Conceptual Review Agenda

Re: College & Conifer - Vehicle Repair

Fort Collins Block 32 & 42 Community Facilities

LAYOUT A1 AERIAL OVERLAY PLAN

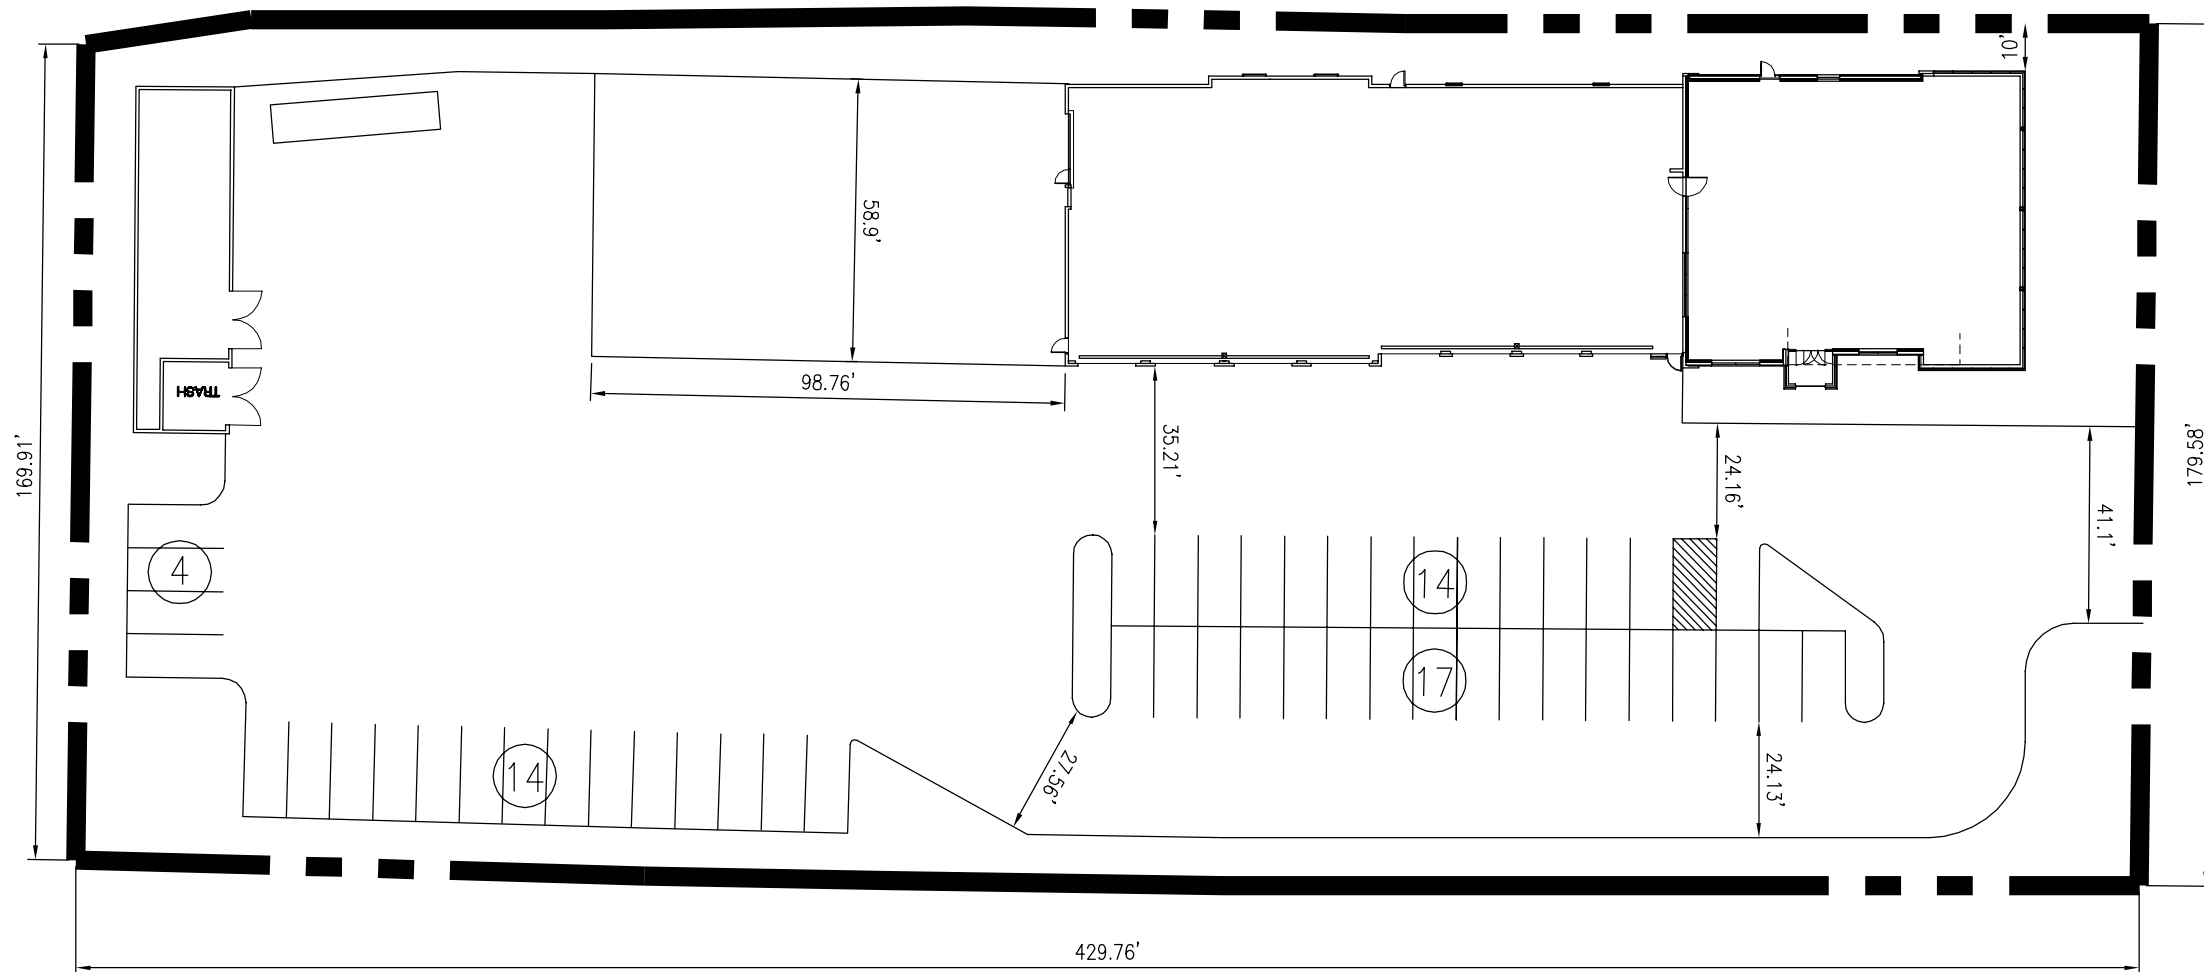
The proposed site plan places the building out of fire access and as such a fire lane onto the property will be required. A turn around is also needed. For more information, refer to fire lane specifications provided here.

Option A

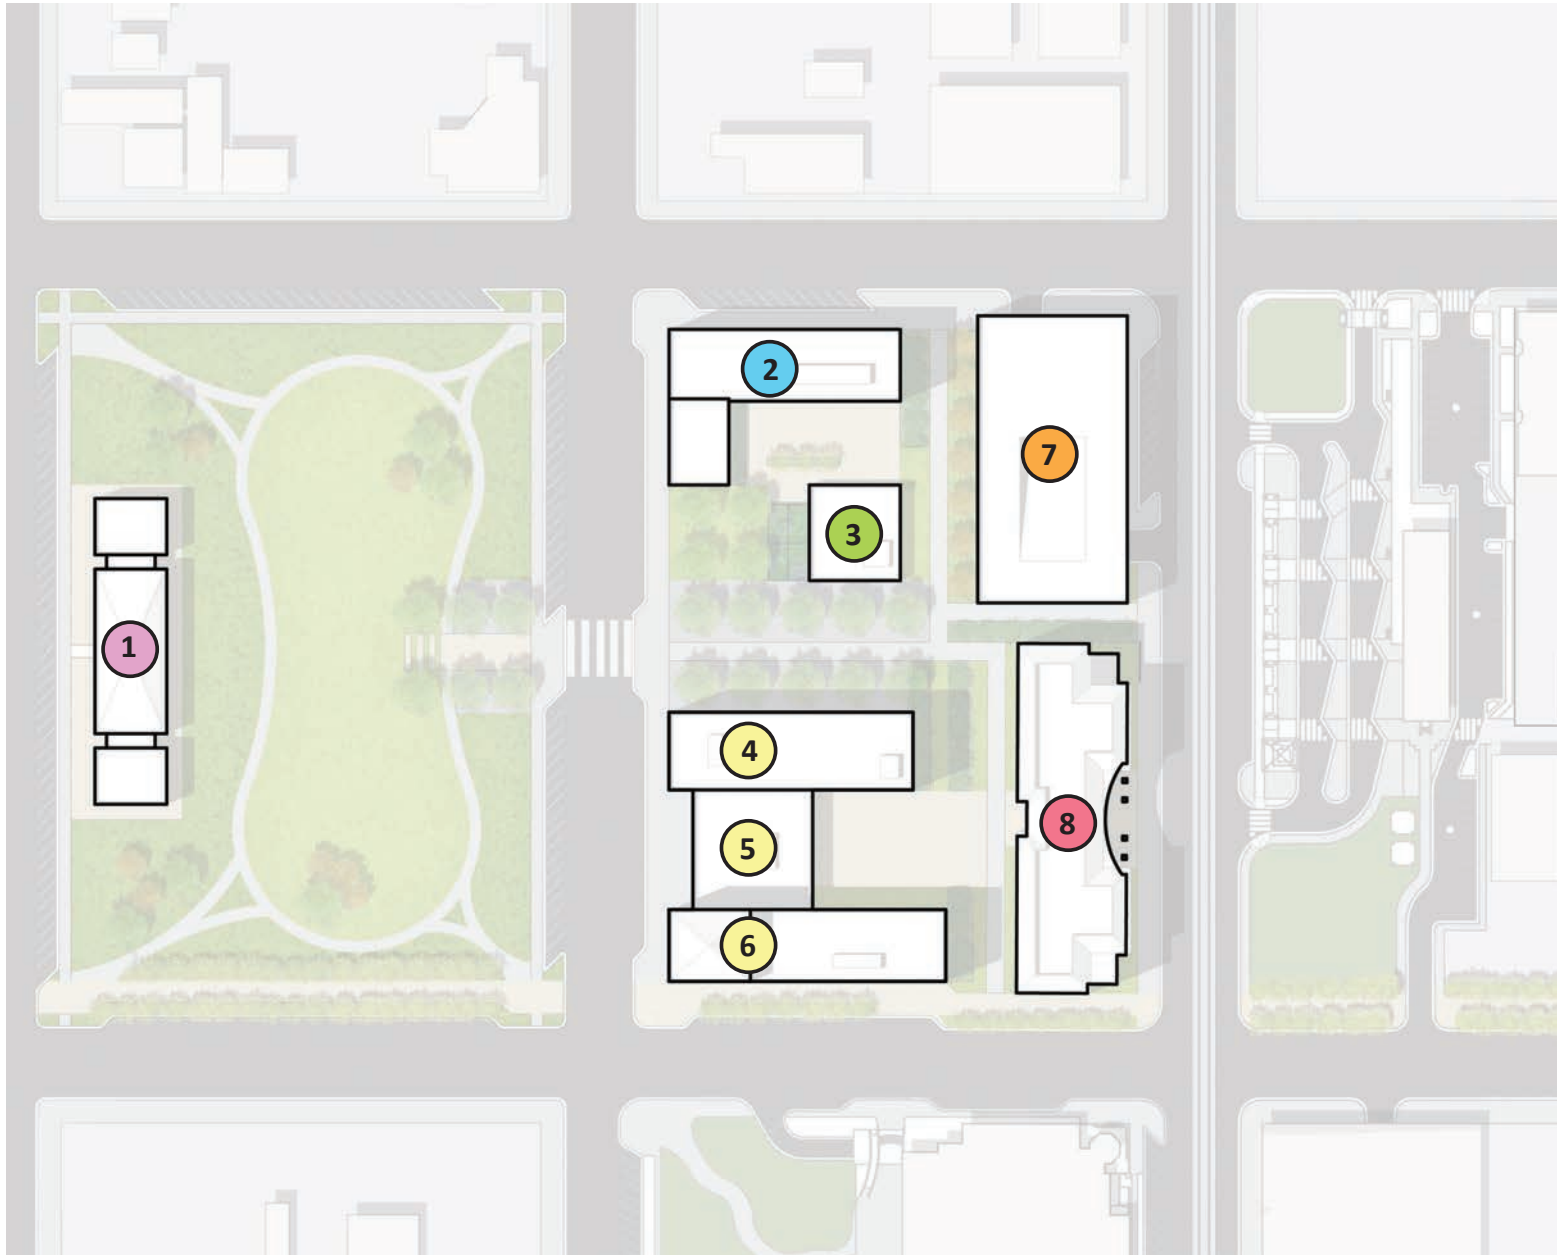
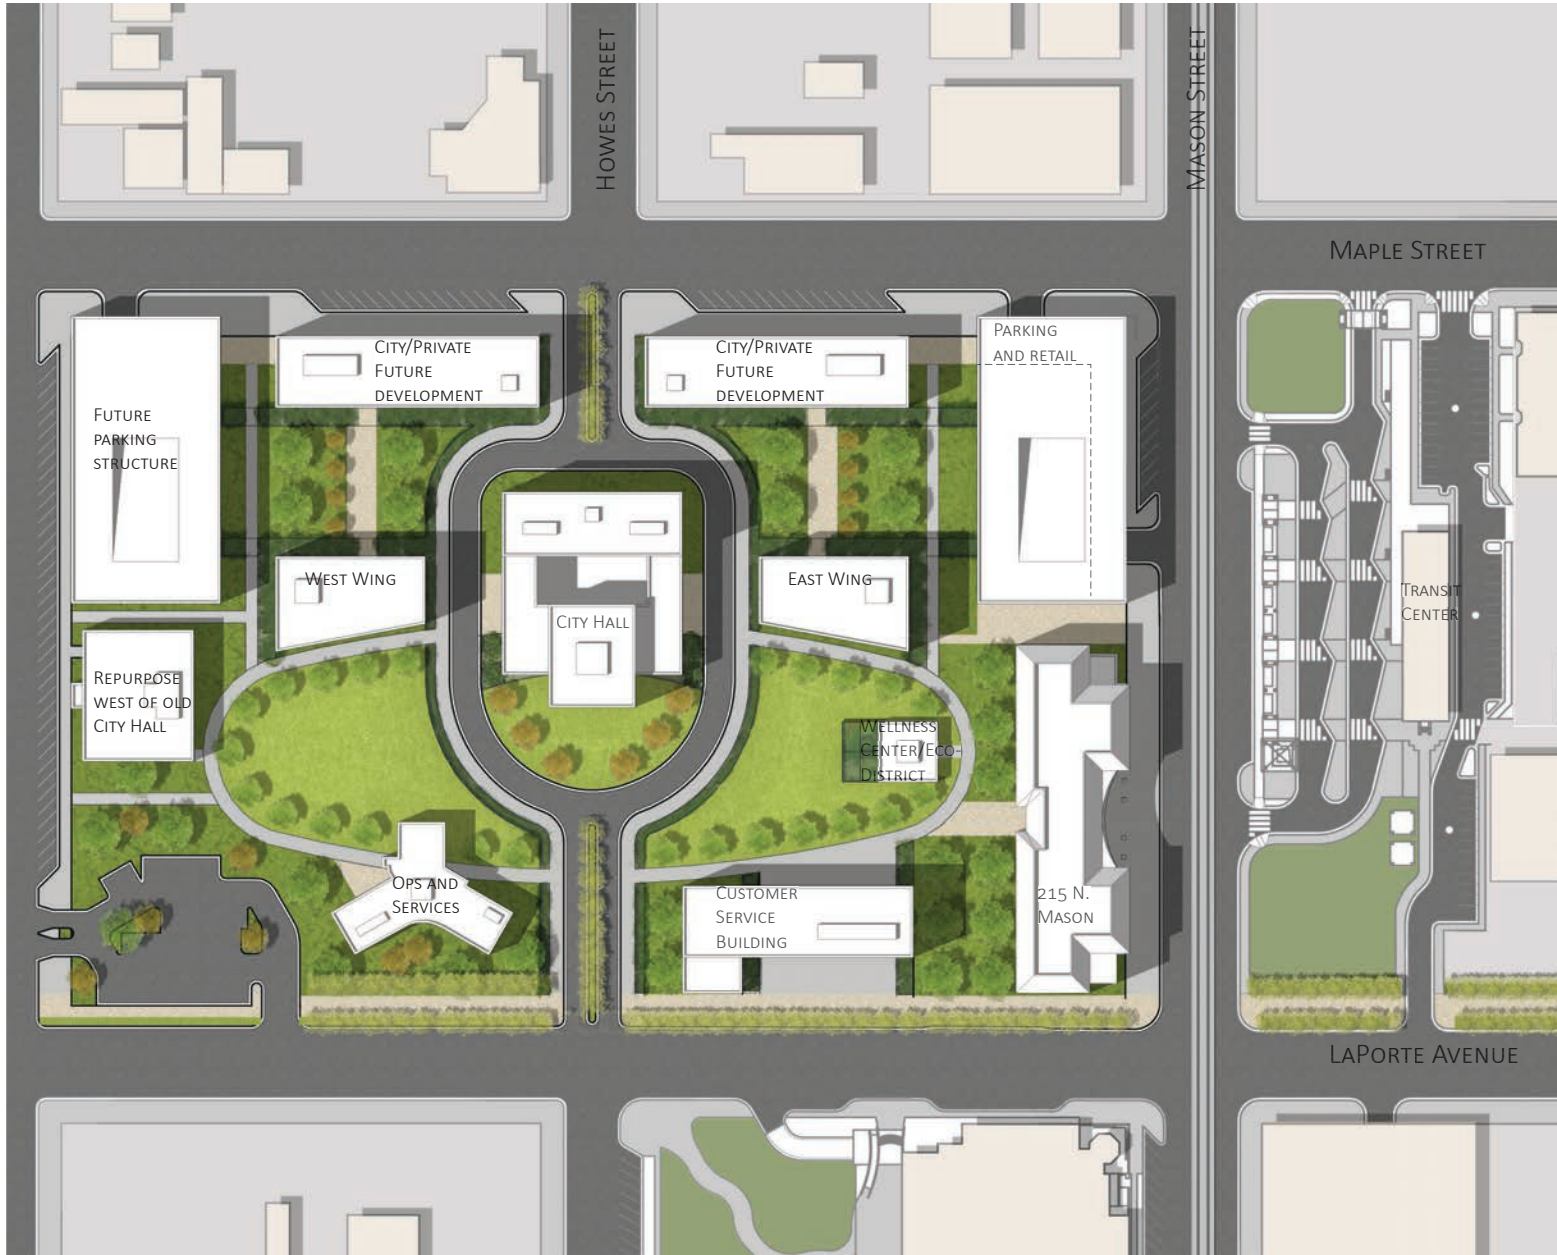
3. Both of the plans for Blocks 32/42 fail to comply with LUC Section 3.4.7, as the plans fail to retain the historic resources and incorporate them into the new development or show why, to the maximum extent feasible, this cannot be done.

As fire access is concerned, neither site plan option (#3 or #9) is favored over the other option; rather, both options appear to have access challenges to overcome. Perimeter roads and access roads through the campus do not appear to be located within 150' of all portions of all buildings. When roads are not sufficient, strategically locating drive aisles, also serving as pedestrian pathways through the site may be an acceptable method of achieving full access. It is highly recommended the fire department be involved in the early stages of the planning process. Feel free to contact me at any time to discuss this further.

1. 2013 - City Hall on Bock 32: Proposed concept needs to comply with the Civic Center Master Plan that describes a primary pedestrian "spine" (north/south - mid block) between Laporte Ave and Cherry Street. This pedestrian connection has been planned since 1995 and presently connects the County Administration building on W. Mountain through the Courthouse block and across Laporte St. - and north through a portion of Block 33.

Option B

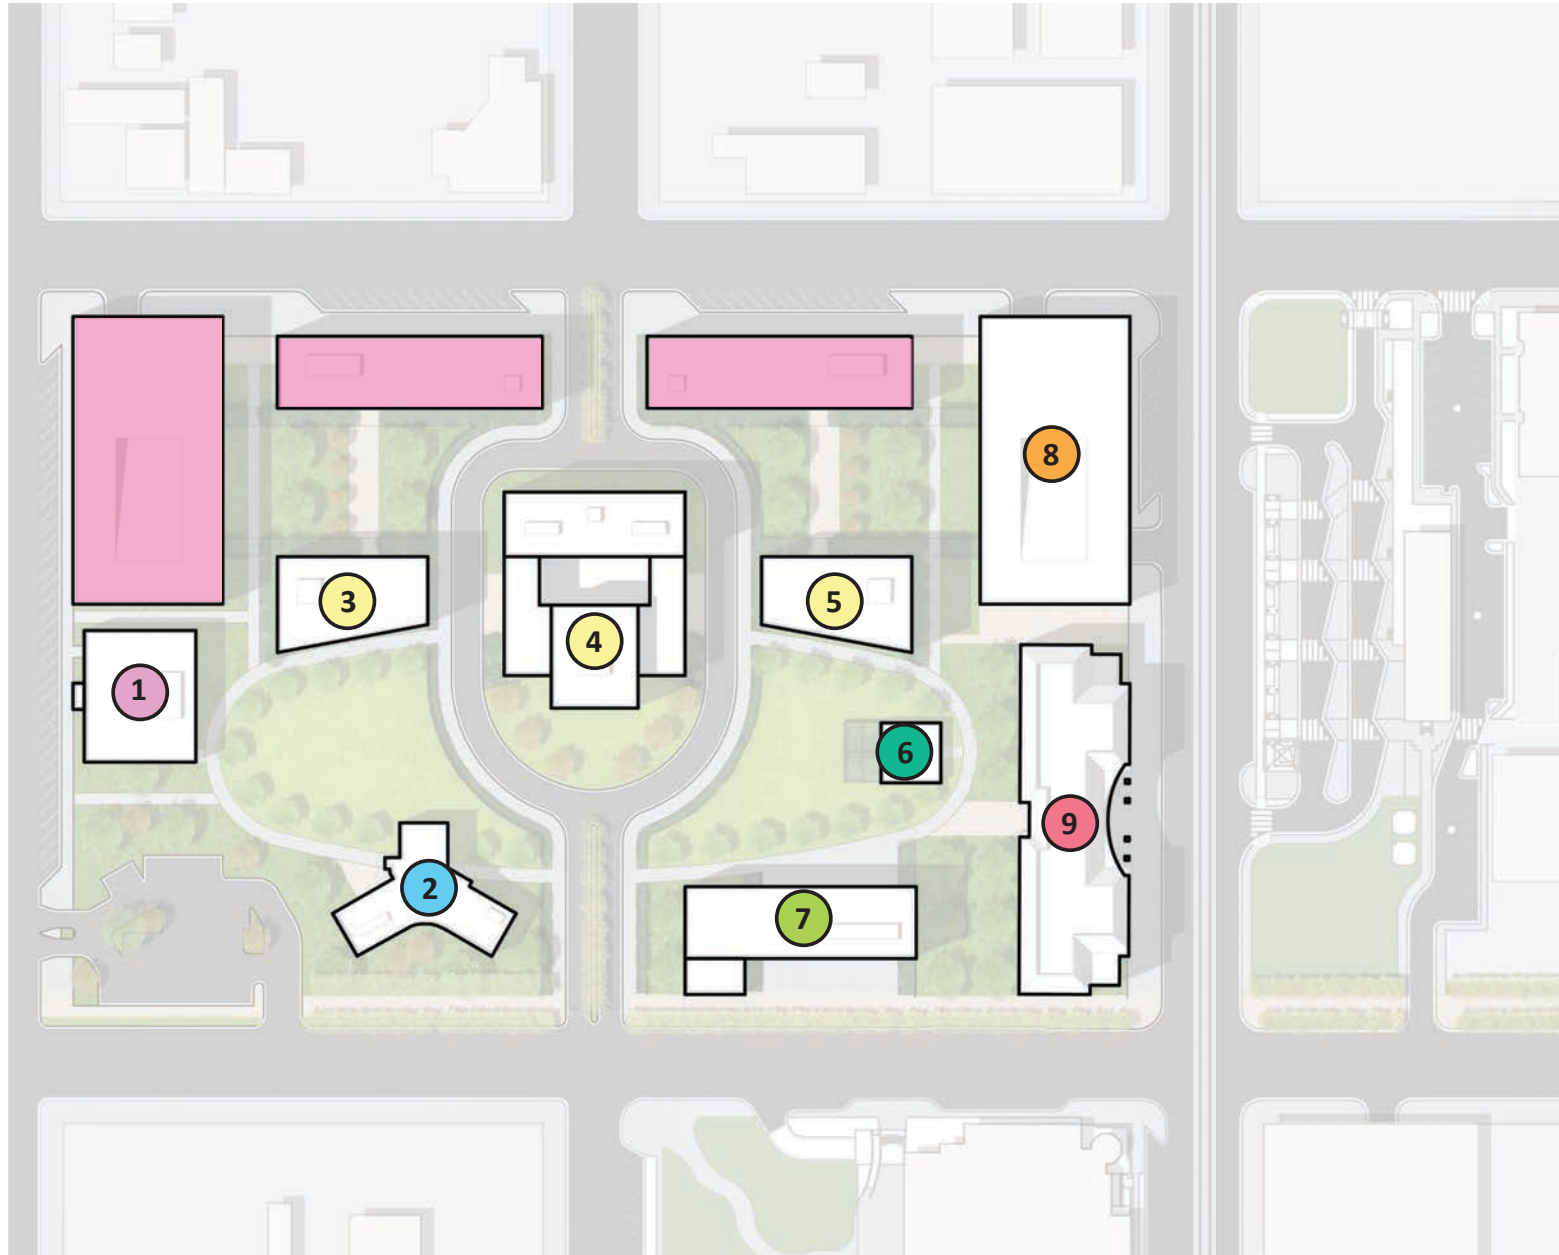
1. Light & Power has existing electric facilities running through and adjacent to blocks 32 & 42. These facilities would need to be field located and shown on the construction drawings. Any relocation or modification to the existing facilities would incur system modification charges.
2. Option B would be the most problematic as far as electric facilities. Light & Power has an existing large electric duct bank running North & South along the East side of Howes St. With Option B this duct bank would need to be relocated at a fairly high cost.

6. Traffic Operations Comment: Traffic Operations staff believes that Option 3 is the better alternative when considering the Transportation needs in the area. Howes is an arterial street that carries about 3,000 vehicles per day. With the advent of the MAX BRT and associated changes on Mason Street, Howes may become even more important as a north-south transportation route in the future.
